Ballard Pump Station

Meeting Summary

This was the Seattle Design Commission's (SDC) first review of the Ballard Pump Station project. The purpose of this meeting was to review the concept design phase. After the presentation and discussion, the SDC voted 6-3 to approve the concept design phase for Ballard Pump Station project with several conditions and recommendations.

Figure 2: Proposed site plan

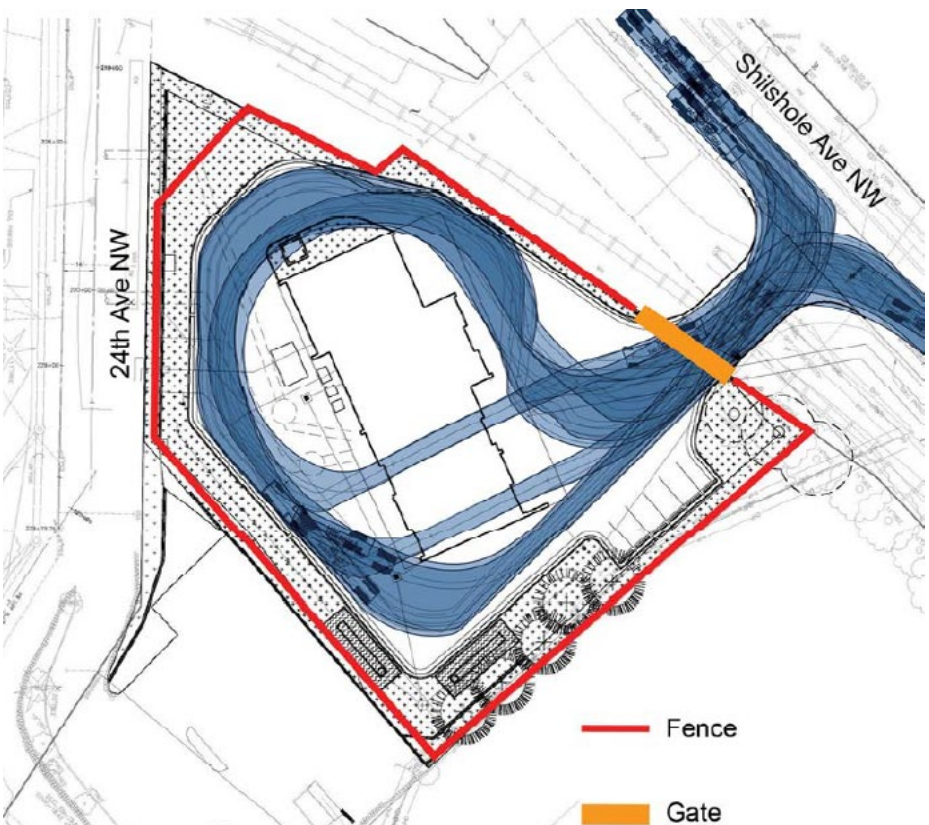
To reduce the amount of impervious surface on the site and to increase the efficiency of the site, the commission recommended that the project team explore alternative circulation options that would not require trucks to circle around the entire site. The Commission thought this could be achieved by having an additional curb cut on 24th Ave NW and maintaining the curb cut proposed on Shilshole Ave NW with a driveway along the east side of the site to connect the two curb cuts. Commissioners indicated that this type of solution would still allow access for semi-trucks and firetrucks that need to access the site annually and reduce the amount of impervious surface. Commissioners also recommended the design team consider rotating the facility footprint to accommodate alternative circulation patterns as well as a greater amount of publicly accessible space. See figure 4 for more detail

The SDC encouraged the design team limit security fencing to only areas that needed to be secured rather than fencing the entire perimeter of the site. Commissioners recommended the exterior of the building be accessible to community members.

1. Create a stronger conceptual framework to drive the relationship between the site design, architectural design, and the public realm
2. Reevaluate site circulation in a way to minimize the amount of impervious areas
